ARC REVIEW CODE: R2111011

Name of Proposal: Kennemore DRI 3404

Review Type: Development of Regional Impact **Date Opened:** Nov 1 2021 **Date Closed:** Nov 23 2021

KENNEMORE TRACT DRI
Forsyth County
Natural Resources Group Review Comments

A OVERALL SITE PLAN
SP-1 SCALE: 1"=200'-00"

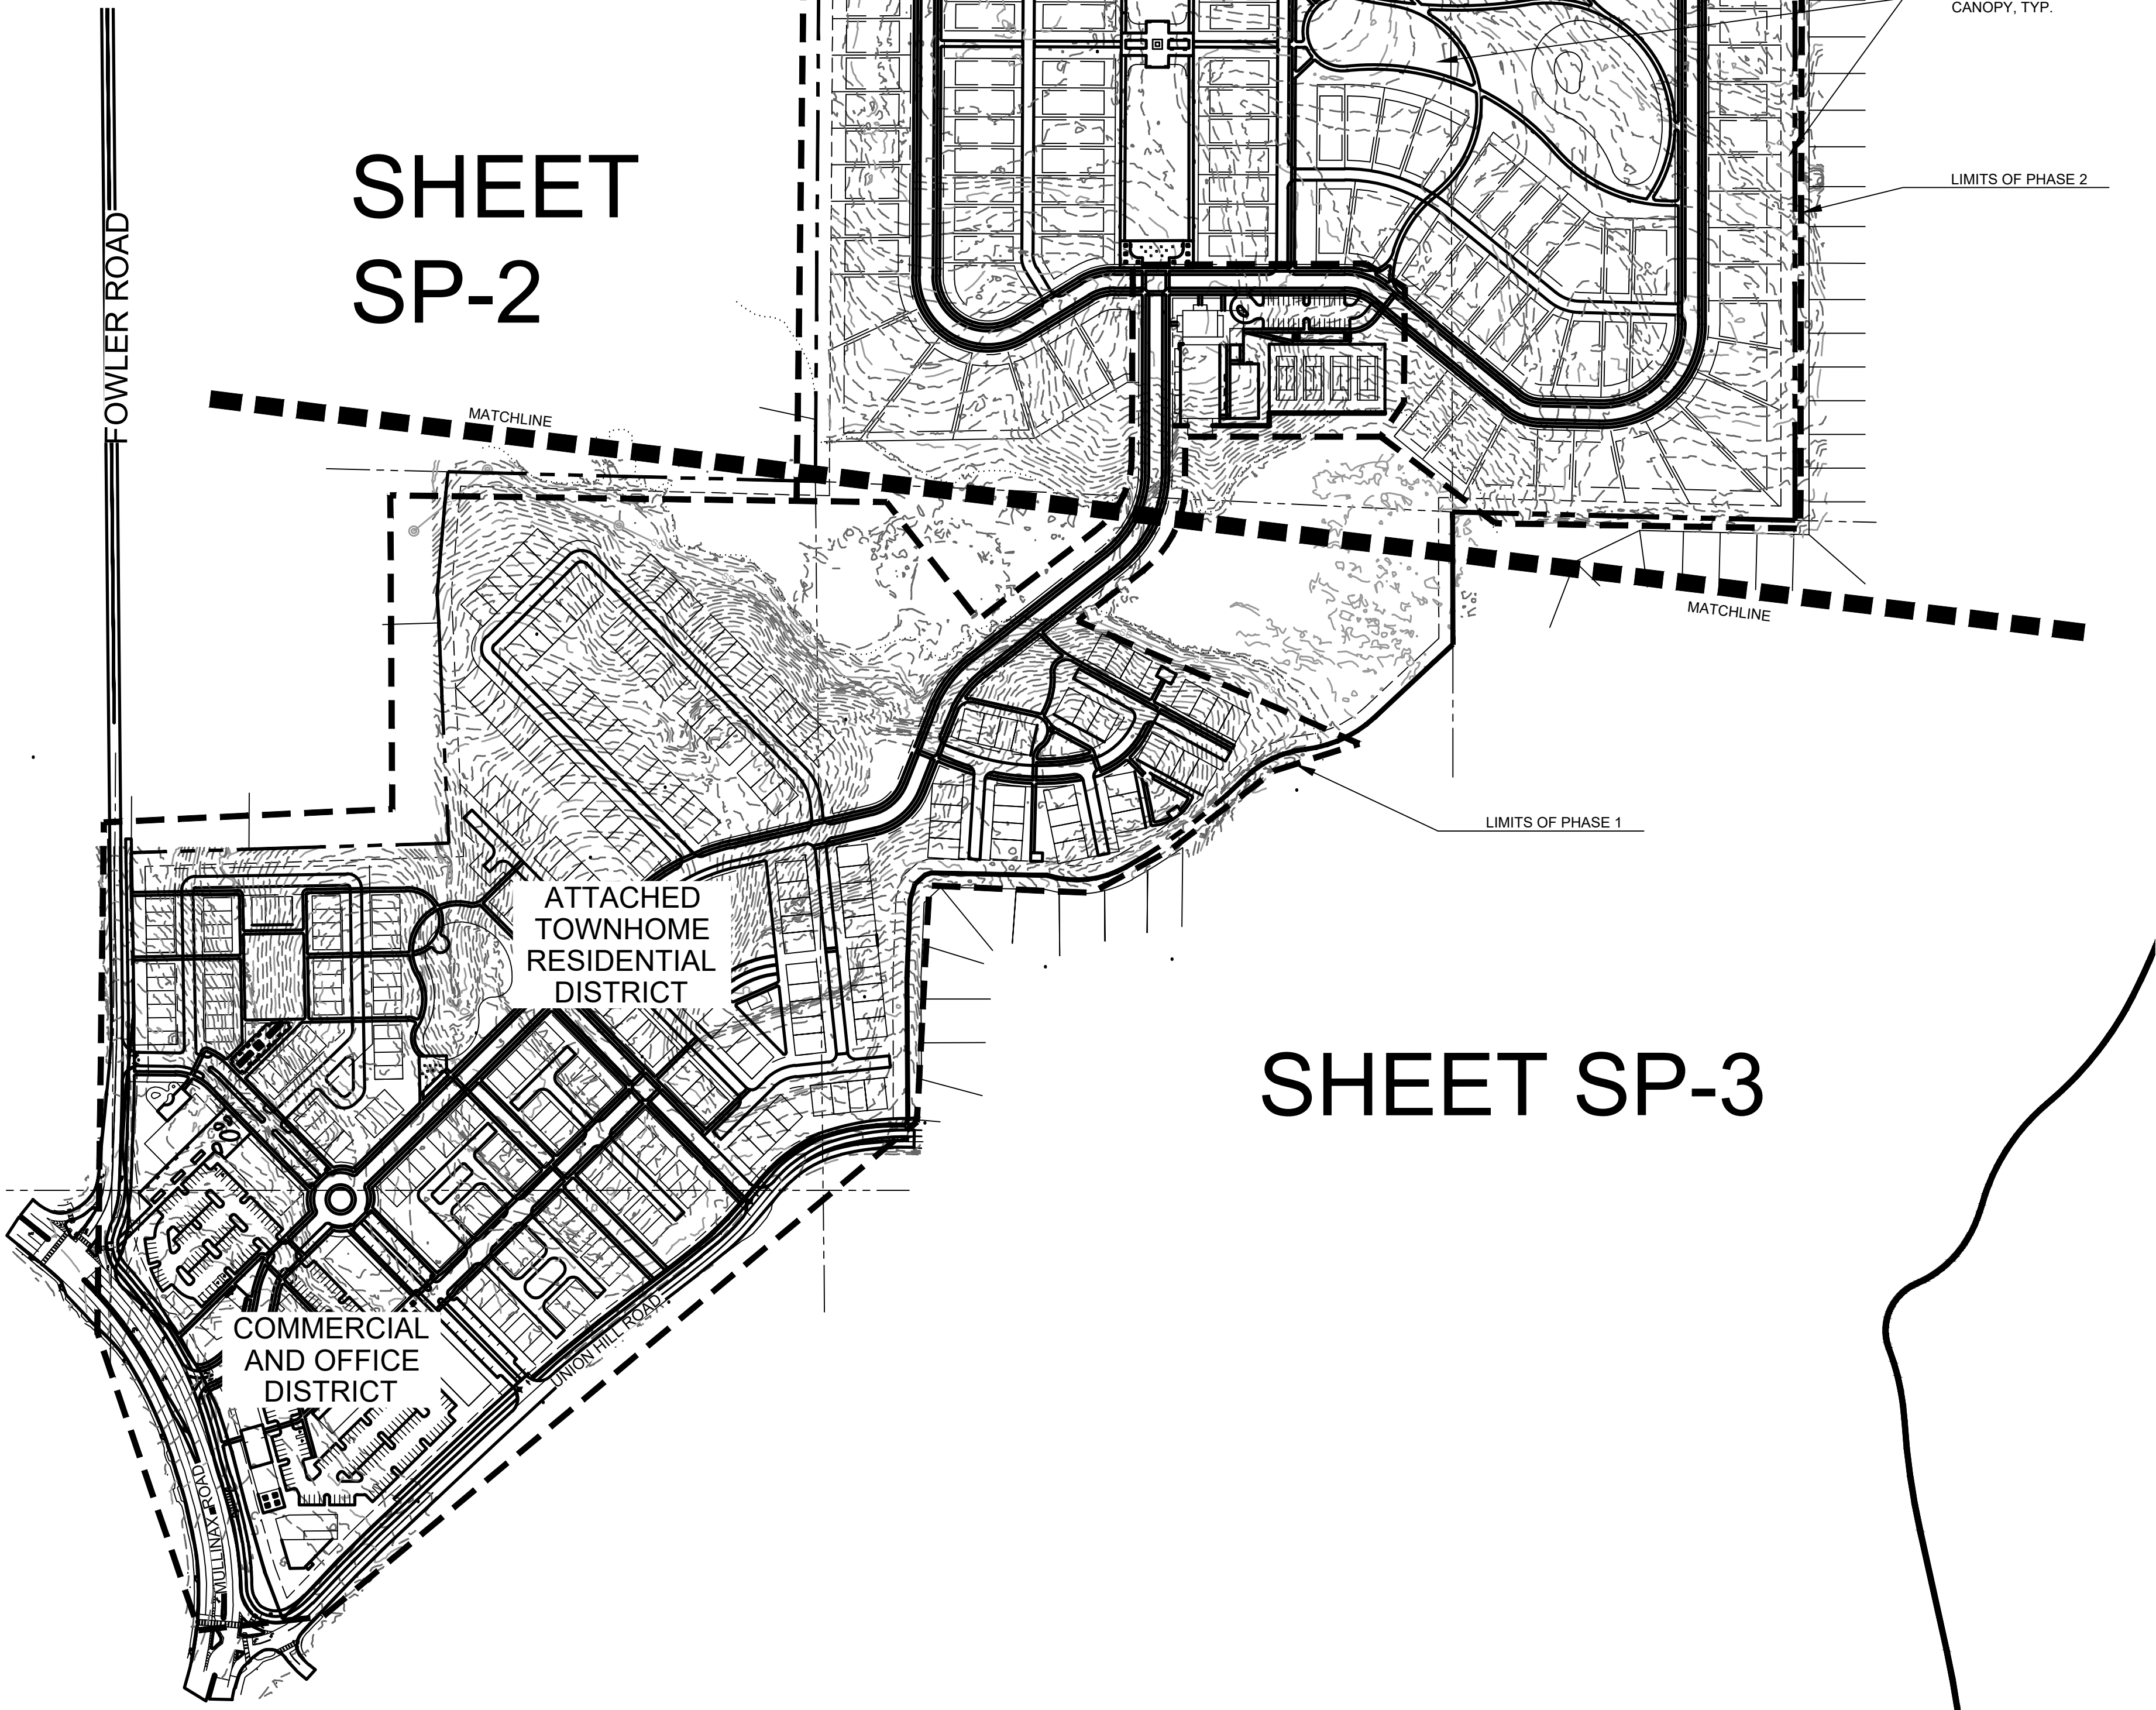
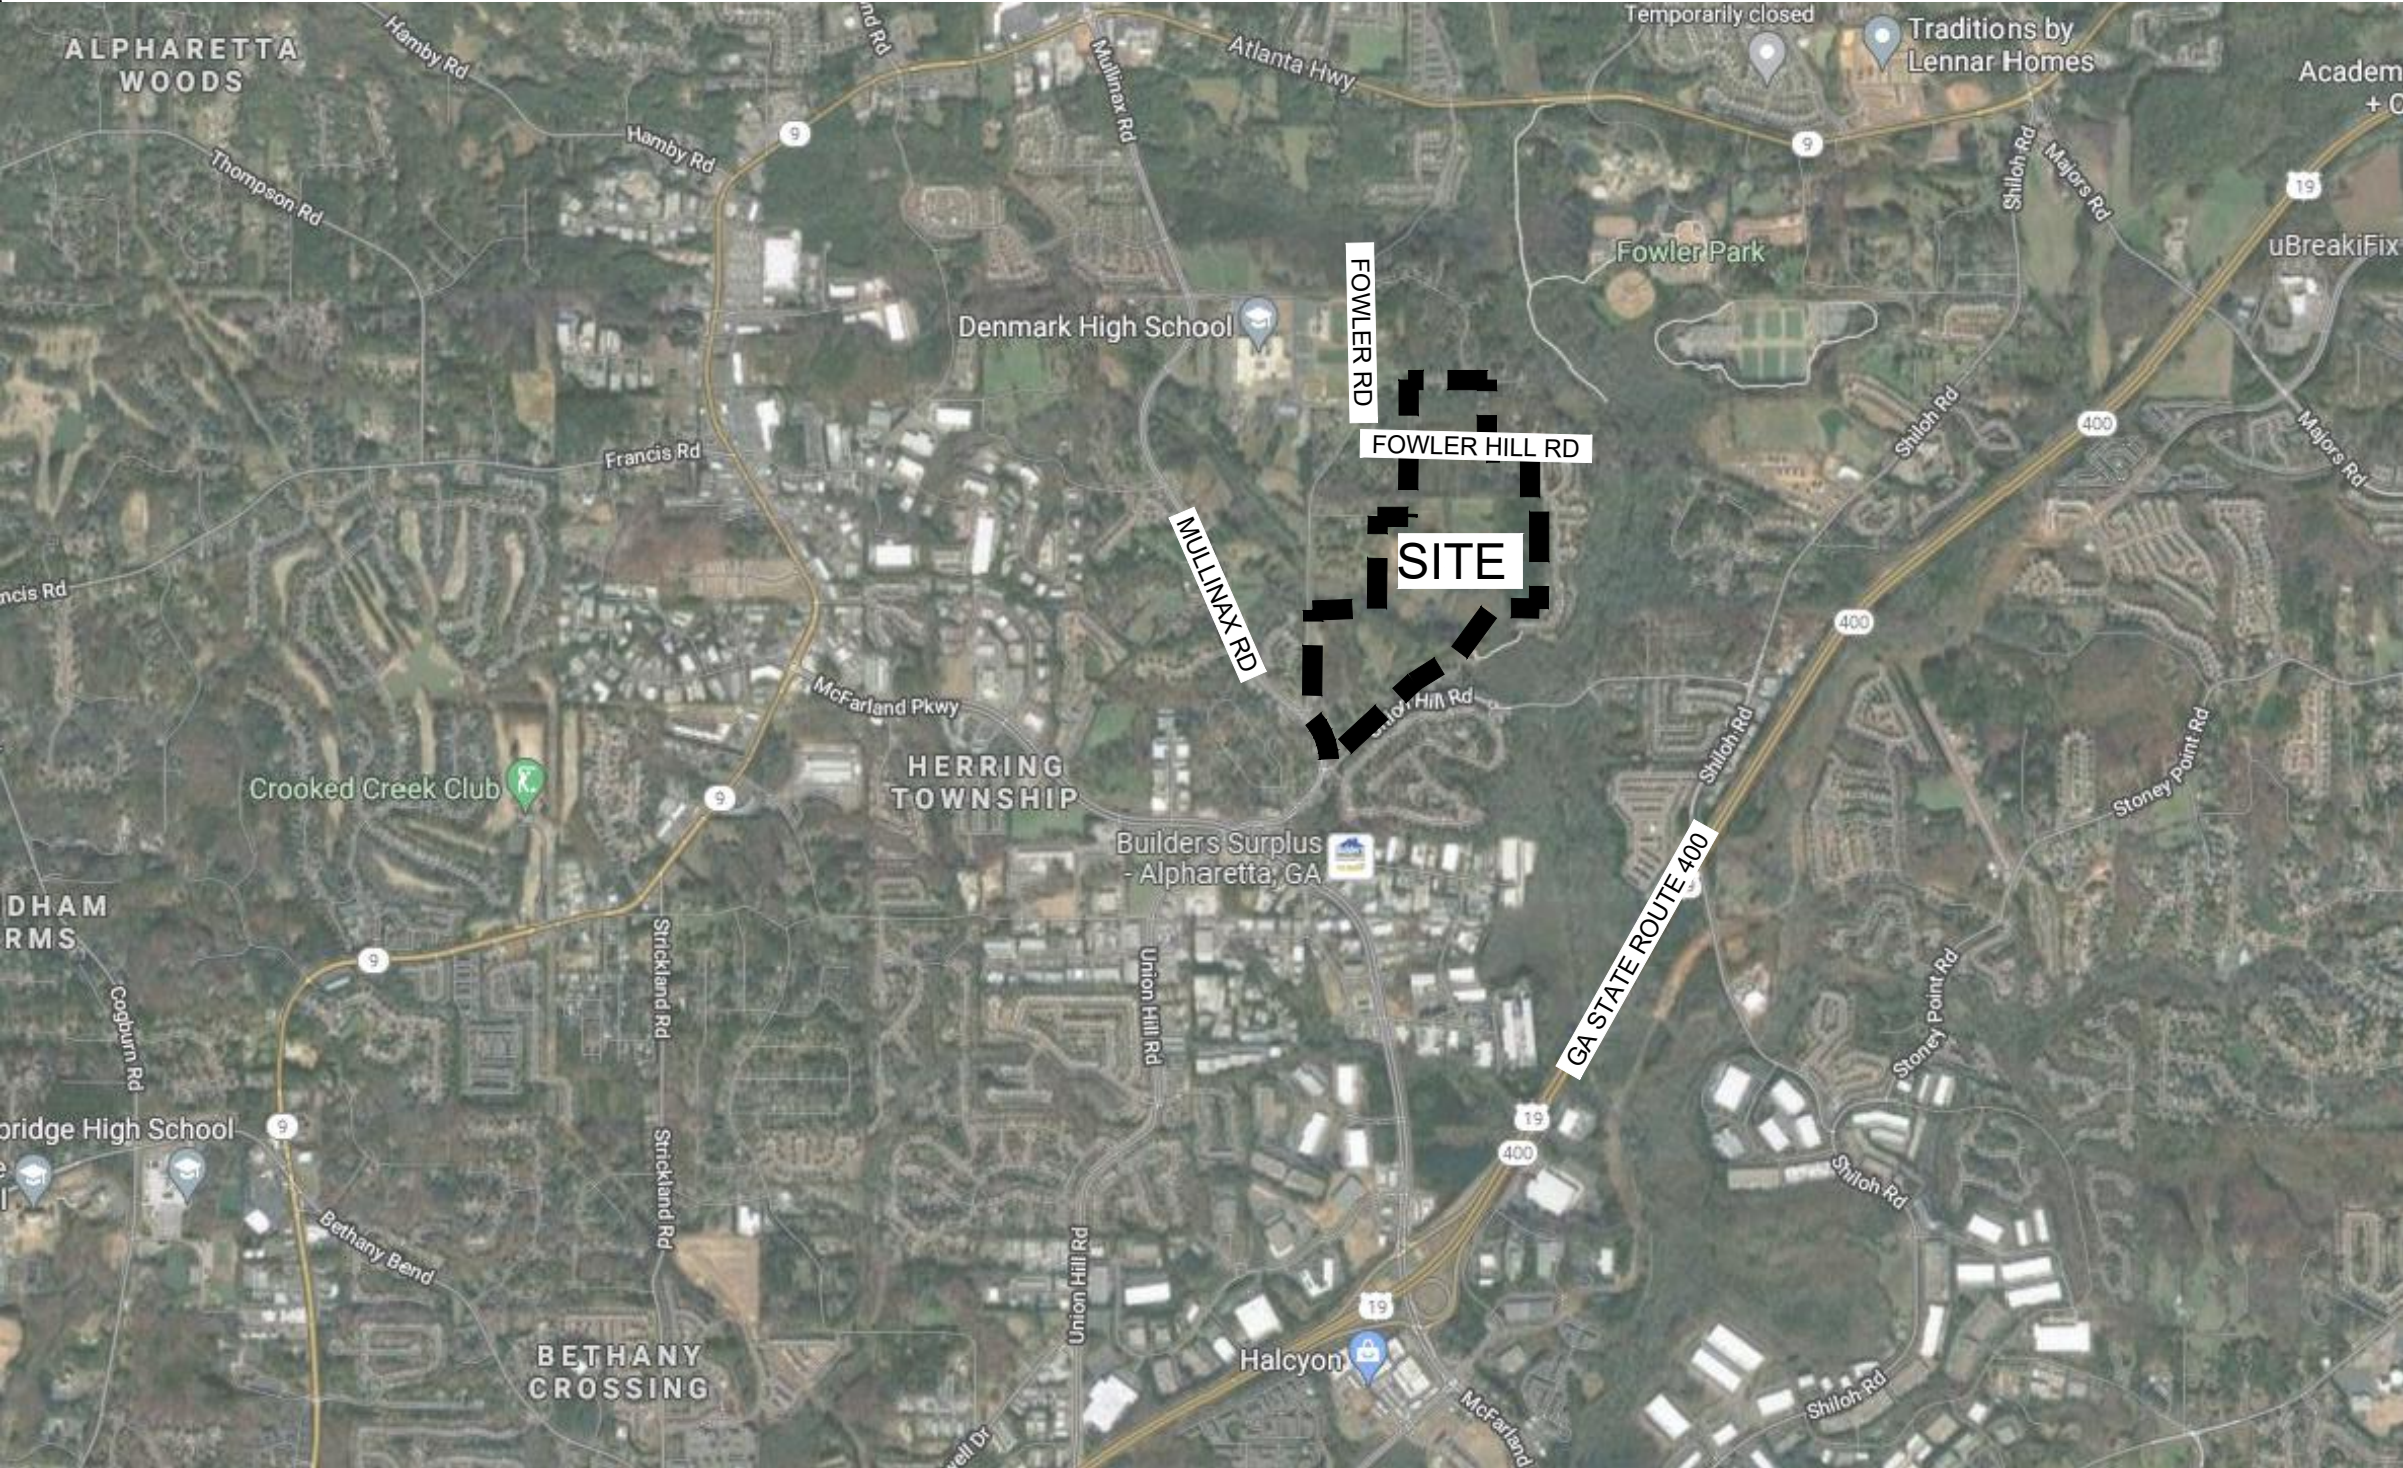
The project proposes approximately 1,370 parking spaces which is close to the 1,300 minimum number of spaces required. This is consistent with the provision of measures that would allow adjacent destinations to be reached on foot or by bike and with regional and local policies promoting walkable development. To these ends, some further reduction in required parking is worth considering.

Hill Road to its eastern terminus, to a new path entrance point. This plan is indicated on the DRI site plan, sheet 2. ARC supports this effort to enhance connectivity to this regional amenity. There is also an existing Greenway entrance located just a few blocks from the southeastern edge of the project site on Union Hill Road, but there is limited sidewalk infrastructure that connects to it from the closest DRI site driveways (C and D). Ideally the project's Union Hill frontage would include a sidewalk that could eventually link to the Greenway which provides a safe, off-road connection to dozens of destinations within biking and walking distance, including Forsyth County's 85-acre Fowler Park to the north and the mixed-use Halcyon community to the south.

The USGS coverage for the project area shows a blue-line tributary to Big Creek crossing the center of the project property which is not shown on the plan. Four wetland areas and three intermittent streams are generally located on the plan, but their exact limits and the buffer areas associated with them are not shown. As a result, it is unclear if elements of the proposed project intrude into the buffers. All riparian elements and their associated buffers should be shown in a clear manner, and any intrusions into buffers should be noted. The proposed road crossing connecting the two halves of the property is exempt from the County buffer requirements. Any other buffer intrusion not exempted under the County stream buffer ordinance may require a variance from the County. Any other unmapped streams on the property may be subject to County stream buffer requirements.

The USGS coverage for the project area shows a blue-line tributary to Big Creek crossing the center of the project property. While the stream is not shown on the site plan, the stream floodplain and associated wetlands are delineated. No stream buffers are shown. While the floodplain appears to extend beyond the Forsyth County 50-foot stream buffer and 75-foot impervious setback, they should be shown on the plans, along with the 25-foot State erosion and sedimentation buffer. The only intrusion into the floodplain that may affect the buffers is the proposed road crossing connecting the two halves of the property. Transportation crossings are exempt from the County buffer requirements. Any other buffer intrusion not exempted under the County stream buffer ordinance may require a variance from the County. Any other unmapped streams on the property may be subject to Forsyth County stream buffer requirements. All state waters on the property will be subject to the 25-foot State Erosion and Sedimentation Act buffers.
